Comments and proposals regarding SC-FEC sublayer lane alignment process

Leon Bruckman (Huawei)

- This contribution is in support of comments against the following D1.1 sections:
 - 153.2.4.1.1: Change fas_valid variable definition
 - 153.2.4.2: Change FAS_COMPARE function definition
 - 153.2.4.4: Update Figure 153-7 accordingly and add a new state diagram for lane identification

Lane alignment verification state machine

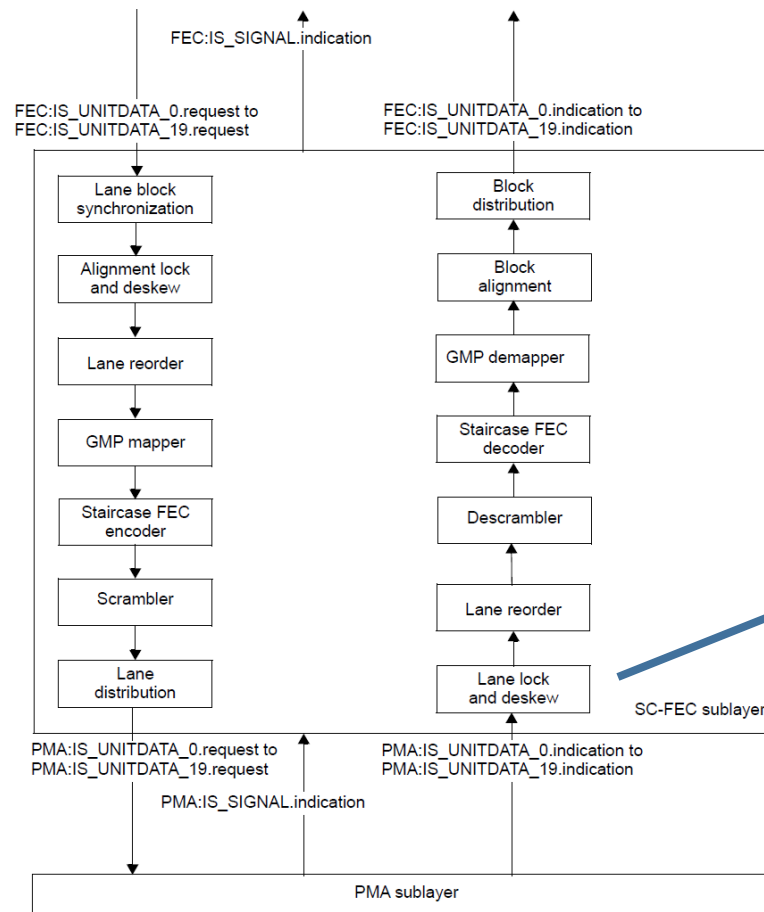
- Separate Lane marker procedures from alignment procedures
 - Option: Configurable detection and loss verification duration
 - Similar separation between block synchronization and alignment marker lock can be found in Figures 82-12 and 82-13.
- Alignment:
 - Detection based on 4 (fixed) FAS bytes OK
 - Loss detection based on: 3 (fixed) FAS bytes not OK
 - Option: Configurable loss verification duration
 - Note that usually alignment loss verification is relaxed compared with line alignment detection
- Advantage:
 - Developers will be able to reuse the same functions/hardware they developed for OTN similar signals.
 - We are “borrowing” the signal from OTN (simplified)
 - Testing for alignment problems simplified by separating functions
